RE: Special Permit – Section 11– Flood Plain Protection Overlay District  
Lot 2 – 300 Stone St.  
Proposed Single Family Residence

DATE: December 15, 2020

- A three sheet 24”X36” plan set titled “Site Development Plan Lot 2 – 300 Stone Street Walpole, Massachusetts” Prepared For: Walsh Brothers Building Co. Inc. 10 Saddle Way Walpole, Ma 02081” dated December 17, 2019 prepared by GLM Engineering Consultants, Inc.
- A digital request for review within the View Point permitting system dated October 22, 2020 with comments due by December 16, 2020.
- Various other application materials of varying dates uploaded to the View Point system.

DRAIN EASEMENT  
 SKETCH TO ACCOMPANY  
 SPECIAL PERMIT REVIEW  
 300 STONE ST.

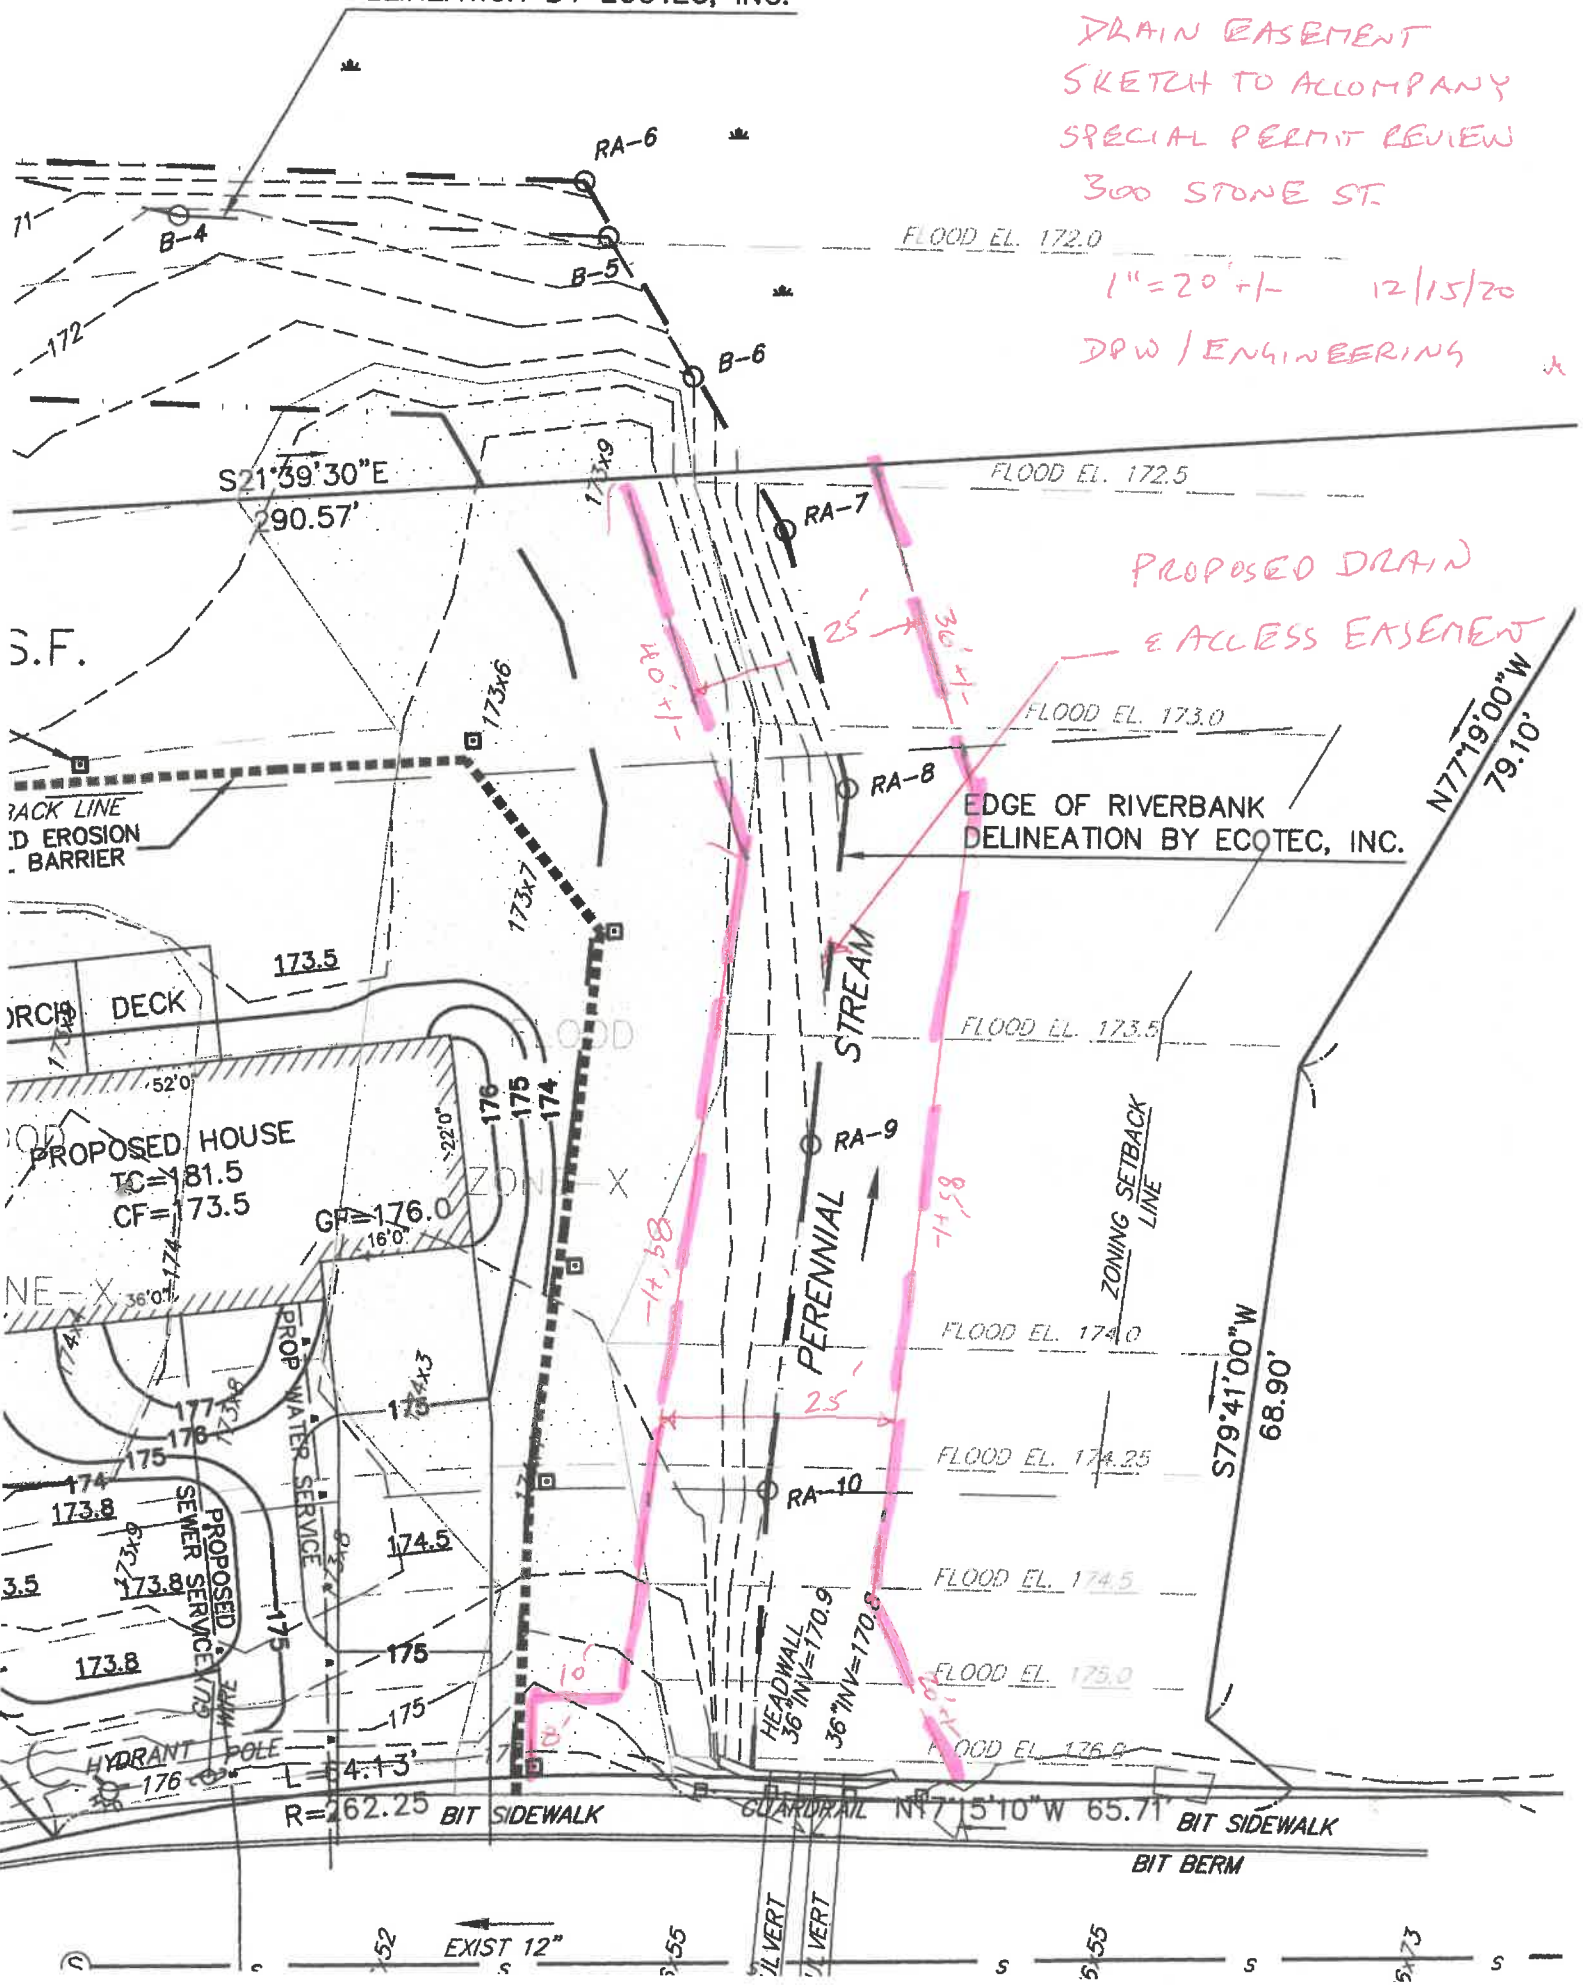
- 6) We ask that the Board require a municipal easement around the Perennial Stream headwall and stream bed for future maintenance. No improvements are planned currently but at some point there will need to be work on the culverts under Stone St. and removal of debris along the stream. A sketch showing approximate location is attached. The exact details of the location of the easement can be worked out with this office. If this is to occur we suggest the applicant provide the easement plan and the Town handle the conveyance documents. If the Applicant has a title search for the lot it should be provided.

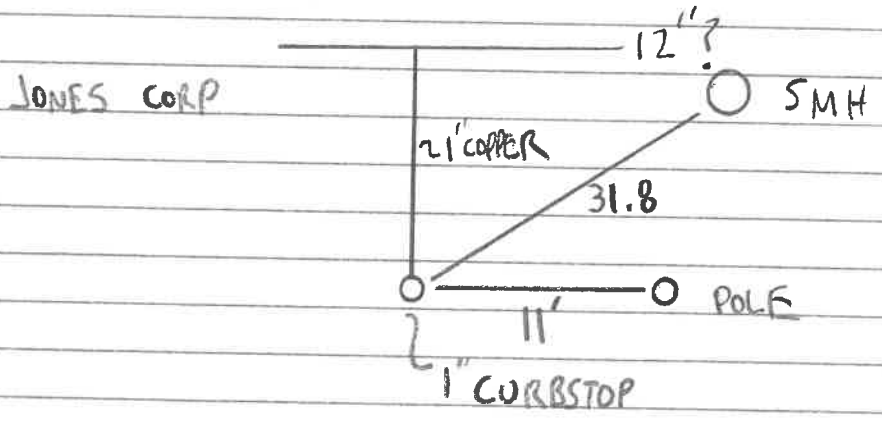
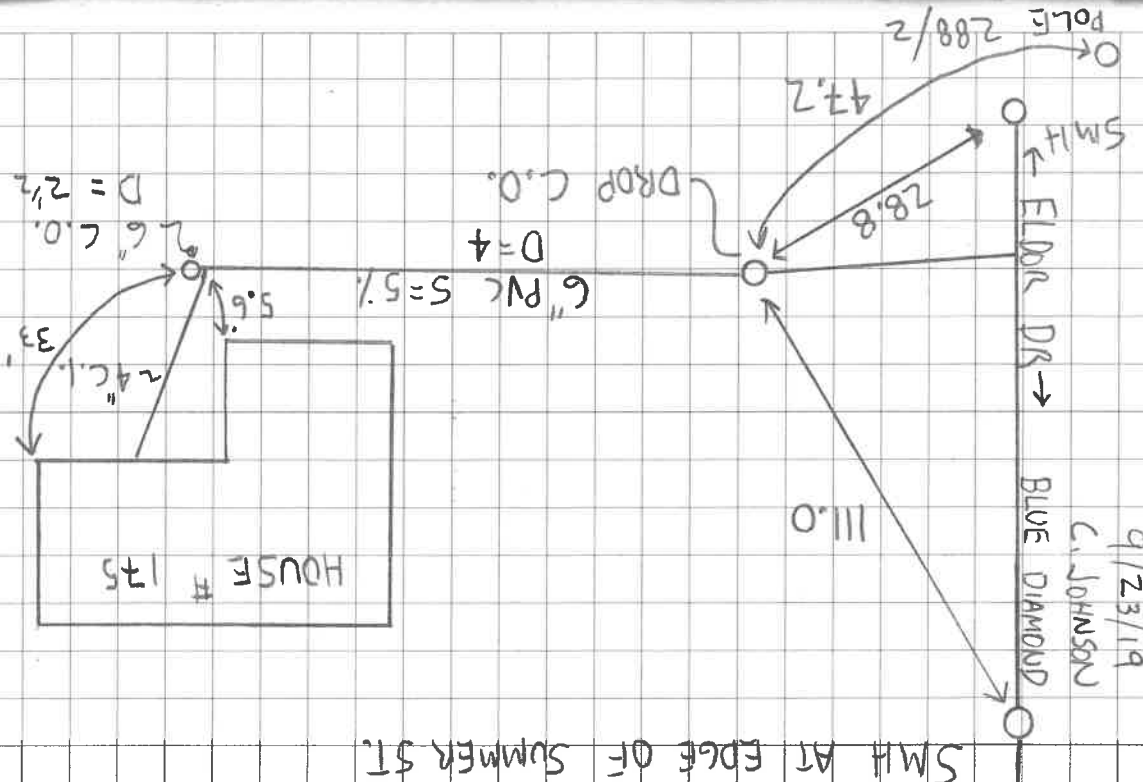
- 1) The proposed design appears to meet the requirements outlined in Zoning Bylaw Flood Plain Protection Overlay District Section 11.3.B. (1-5)
- 2) A foundation drain shall be required. The drain should discharge to daylight somewhere near the end of the proposed grass swale.
- 3) Attached to this memorandum are ties to installed sewer and water services for this lot. The service stubs should be accurately shown on the plans. The sewer stub appears to be very close to the front left (northerly) lot corner. This may need to be re-installed from the back of walkway to keep it on the lot.
